South Texas Project
Units 3 and 4
Docket Nos. 52-012 and 52-013
Revised Response to Request for Additional Information

Attachment: Question 12.02-20, Revision 1

RAI 12.02-20

Figure 12B-1 SFP Layout and Dimensions

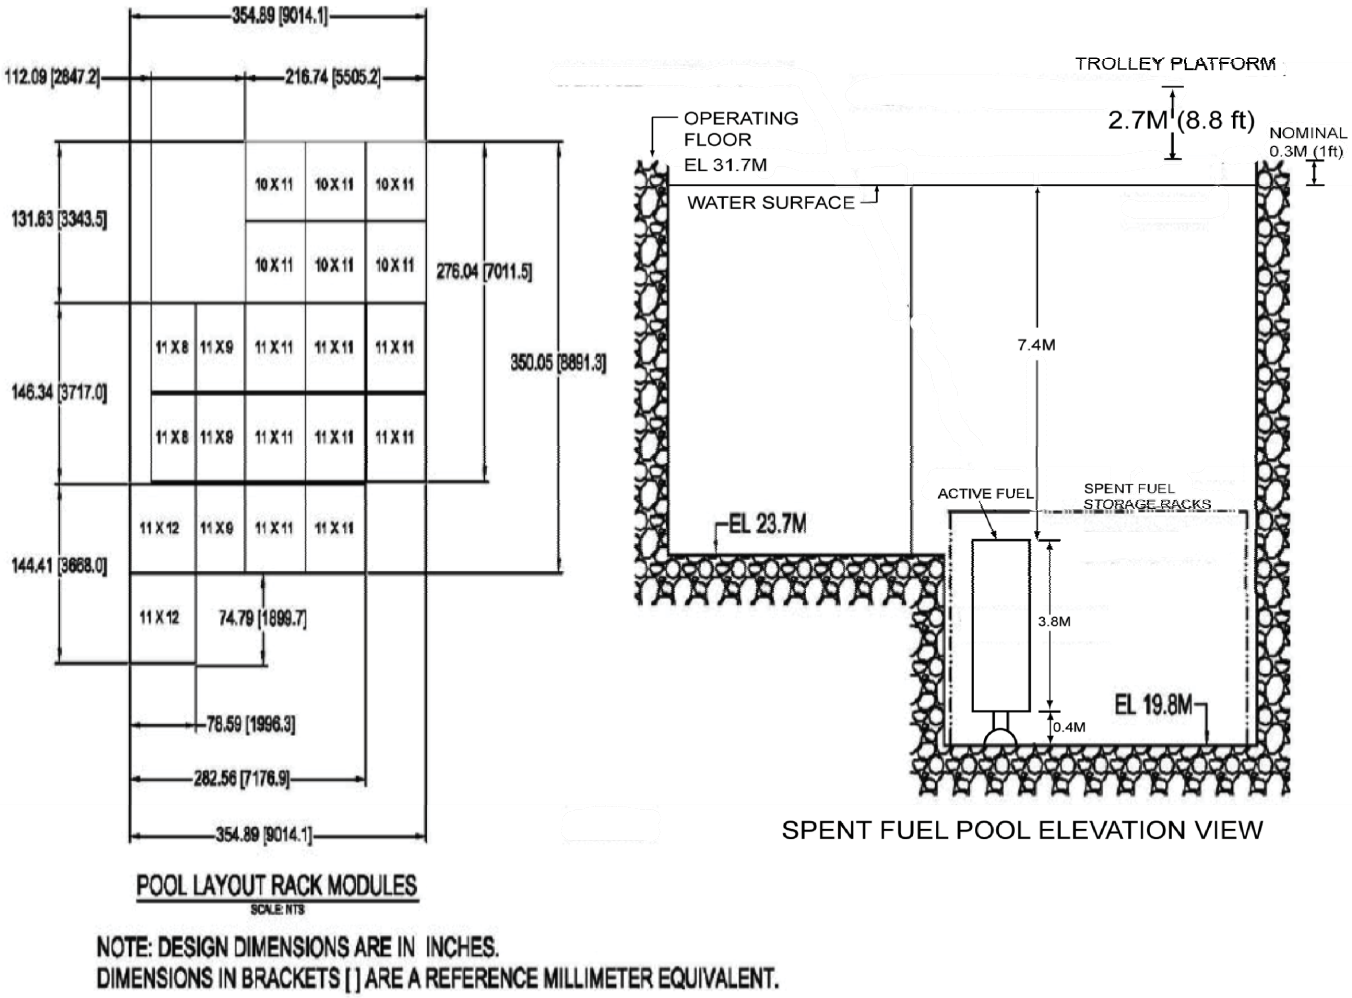
2. A figure was included in the RAI response showing a vertical cut view of the SFP. Some of the dimensions on the figure appear to be inconsistent with the spent fuel storage shielding dimensions shown in Table 12.2-5c of the ABWR DCD and STP 3&4 FSAR. In addition, this figure does not include some of the dimensions and spatial relationships needed by the staff to perform a shielding calculation. Specifically, there appears to be an inconsistency between the depth of water above the fuel assemblies as shown in the SFP figure and the depth of water as indicated in Table 12.2-5c. In addition, the figure does not show the minimum distance between the top of a raised fuel assembly at maximum height and the SFP water surface, the height of the SFP fuel pool bridge above the water surface, and the location of refueling personnel during refueling operations on the fuel pool bridge. In order for the staff to be able to perform an accurate deep dose equivalent calculation for a person standing on the fuel pool bridge, please provide an updated figure of the SFP, addressing these items.

1. The new Appendix 12B shows a representative SFP rack modules layout drawing (Figure 12B-1), with a capacity of 2365 bundles, which is conservative for a dose calculation compared to the maximum 270% (2354) bundles allowed in the SFP, as specified in FSAR Section 9.1. As discussed in the appendix, the radioisotope inventory and gamma and neutron sources, as a function of time post-irradiation, were calculated with the NRC-endorsed ORIGEN-S Code. The supporting proprietary calculations are referenced in this revised response as References 1 and 2.

2. ABWR DCD Table 12.2-5c shows spent fuel storage with 7.4 m of water above the fuel elements stored in the racks at the bottom of the pool in the fully seated storage position. This is consistent with ABWR DCD Figure 12.3-10, which shows the depth of the spent fuel storage pool as 11.9 m (31.7 m – 19.8 m). Reducing this value by the length of the active spent fuel (3.8 m) plus an

additional conservative 0.4 m for the support portions of the bundle and rack seat height at the pool bottom, and approximately 0.3 m for pool water surface level depth below the operating floor results in slightly more than 7.4 m of water above the top of the active spent fuel seated in the racks.

As requested, the following information is provided. The refueling machine design discussed in Reference 4 shows the trolley platform approximately 8.8 ft (2.7 m) above the refueling floor. The refueling machine will have both local and remote controls. An improvement over some other machines allows the operator to locally control motions of the bridge, trolley, and all hoists and grapples from the trolley platform as opposed to operation of auxiliary hoists from the lower bridge. The remote control system consoles will be located in a control room on the refueling floor, providing the operator with all required functions for automatic control of fuel handling. As discussed in FSAR Subsection 9.1.4.1, the fuel grapple design will maintain adequate water shielding of at least 8.5 ft (2.6 m) over the top of the active fuel.

The SFP geometry is provided in FSAR Section 12.2, Tables 12.2-5a and 12.2-5b; and FSAR Section 12.3, Figures 12.3-6 and 12.3-10. The SFP storage rack has the capacity for 2365 BWR fuel assemblies. The size and configuration of the storage rack are given in Figure 12B-1, which shows an irregular rectangular cross-section area extended to 10.7 m x 9.0 m. The fuel storage rack is situated at the lowest level of the SFP, where the total height of water is 11.6 m.

Figure 12B-2 SFP Centerline Dose Rate

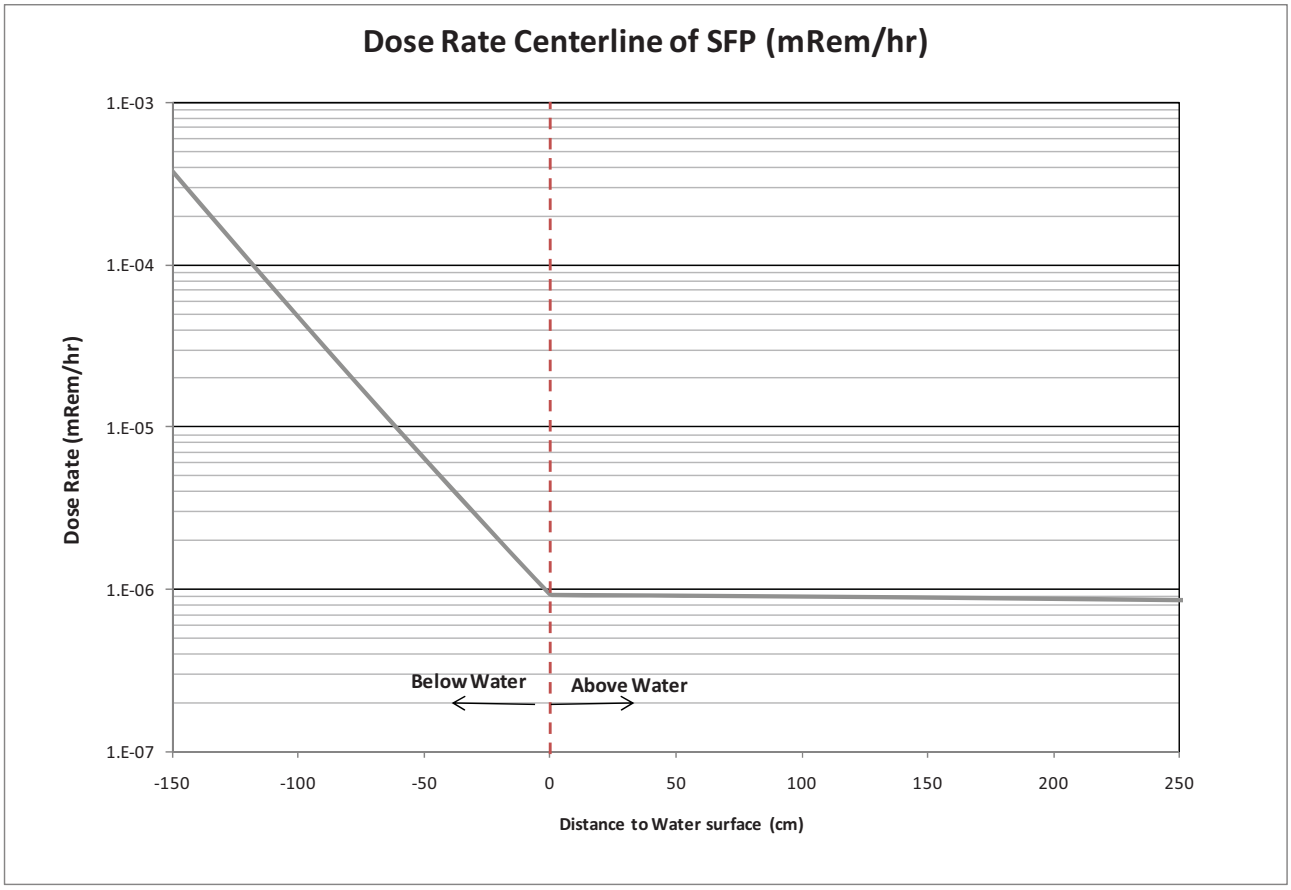
1. The response includes STP 3&4 FSAR revisions to ABWR DCD Tables 12.2-5a and 12.2-5b as well as new Tables 12.2-31 (SFP Peak Gamma Radiation Source) and 12.2-32 (SFP Peak Neutron Source). These new tables provide the source term for the Spent Fuel Pool (SFP) based on 270% of the core load one day post shutdown. However, the response does not include a source term for radionuclides (corrosion and fission products) contained in the SFP water. This information is necessary to perform radiation dose calculations for workers standing on the fuel handling bridge and to completely satisfy Tables 12.2-5a and 12.2-5b of the ABWR DCD, which state that the SFP radiation source and geometry information is the applicant's responsibility. Also, Regulatory Guide 1.206, Section C.I.12.2.1 "Contained Sources", states that the applicant is to provide the models, parameters, and bases for all values used to calculate source magnitudes, for normal and accident conditions. Please provide this SFP water source term information and include it in the STP 3&4 FSAR.

The SFP radiation source is used for the shielding design and analysis to ensure radiation levels at neighboring areas surrounding the SFP meet the design criteria. A simplified model of a rectangular parallelepiped of (8.1 m x 8.1 m x 11.2 m) is assumed to represent the SFP. The SFP peak radiation source is assumed to be homogenized over the bottom 3.8 m of the SFP to represent the active fuel length of a typical BWR fuel assembly. There are 2 m thick concrete walls surrounding the SFP on all sides. The floor of the SFP is 2 meters thick as well. The dose rate calculations are carried out with the point-kernel shielding code QAD-CGGP-A (Reference 12B.6-2). The calculated dose rate results indicate all the areas surrounding the SFP meet the reactor building (R/B) radiation zone limits. Figure 12B-2 shows the dose rate profile for a set of detectors along the centerline of the SFP perpendicular to the water surface. Dose rate at the water surface is approximately 0.001 μRem/hr (1E-5 μSv/hr). The dose rates assessed are due to fuel assemblies in the SFP alone. Contributions from contaminants in the SFP water are not included.

Figure 12B-3 Maximum Single Bundle Dose Rate at Refueling Platform

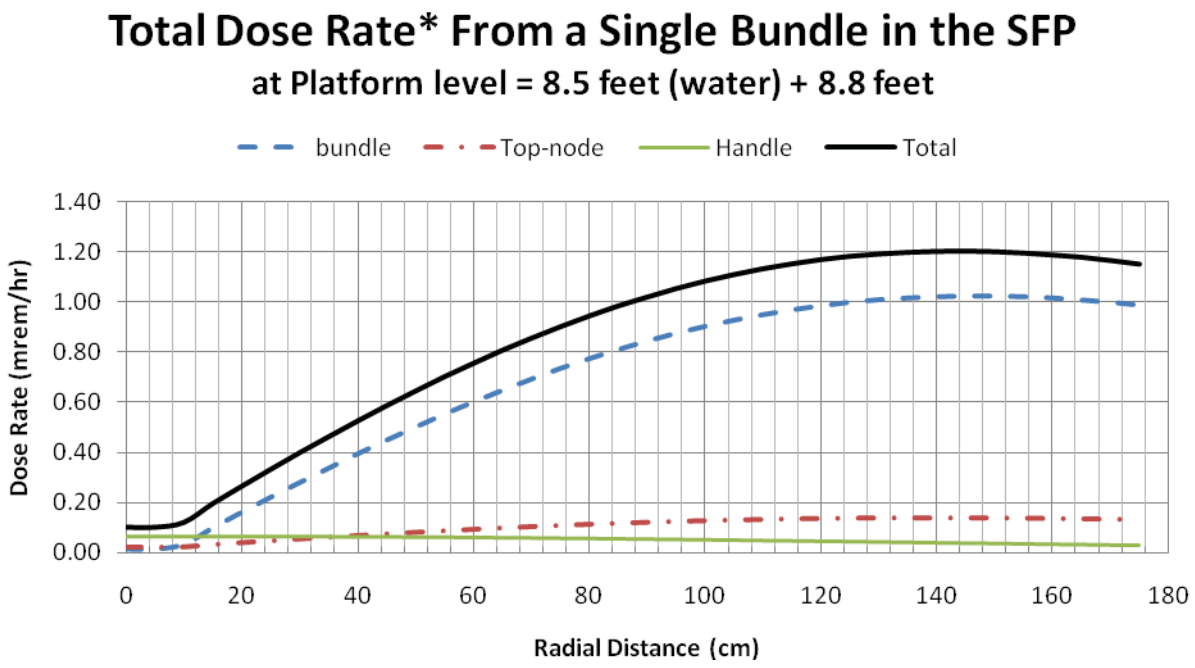
3. As stated in the response to 1. above, additional information is needed in order to perform a radiation dose calculation for workers standing on the fuel handling bridge. During refueling operation ANSI/ANS-57.1-1992 states that fuel handling equipment shall be designed so that the operator will not be exposed to >2.5 mrem/hr (25 μSv/hr) from an irradiated fuel unit, control component, or both, elevated to the up-position interlock with the pool at normal operating water level. Verify that the maximum dose rate to an operator on the fuel handling bridge will not exceed the 2.5 mrem/hr criteria stated in this ANSI/ANS standard.

To ensure an absolute maximum activity bundle is reported, an additional 20% margin was added to the 10% margin, resulting in a bundle source of over 1.65 times the core average. The dose rate at the operating trolley platform from this highest activity fuel bundle, elevated to the maximum up-position in the SFP with water coverage of 8.5 ft (2.6 m) from the top of the fuel assembly active fuel region is approximately 1.2 mrem/hr. This dose rate from the maximum activity bundle with 30% margin added is clearly bounding for any assembly from the 18-month cycle core with a 1.40 peaking factor that will be moved by the refueling operator, and is appreciably below the criteria of 2.5 mrem/hr (25 μSv/hr) stated in ANSI/ANS - 57.1 – 1992, subsection 6.3.4.1.5. The supporting proprietary calculation is discussed in Reference 3 (see page 21). This dose rate, to an operator on the trolley platform at 8.8 ft (2.7 m) above the refueling floor, would be considerably less if credit is given to reduction because of the additional 1 ft (0.3 m) of air space between the water surface and refueling floor, and attenuation through the refueling machine lower structure and platform.

It is assumed that the fuel assembly is lifted to a height of 8.5 ft (2.6 m) below the pool water surface with the operator on the refueling machine trolley platform at a minimum of 8.8 ft (2.7 m) above the water surface. The resulting peak dose rate at 8.8 ft (2.7 m) above the water surface is approximately 1.2 mRem/hr, located at a radial distance from the fuel assembly of approximately 140 cm (4.6 ft) as shown in Figure 12B-3. Even when the maximum fuel pool water source (see Section 12B.5 below) is added, the dose rate remains below 2.5 mRem/hr. For an operator standing on the trolley platform, the dose rate will be less than that shown in Figure 12B-3; therefore the design criteria of ANSI/ANS-57.1-1992 has been satisfied.
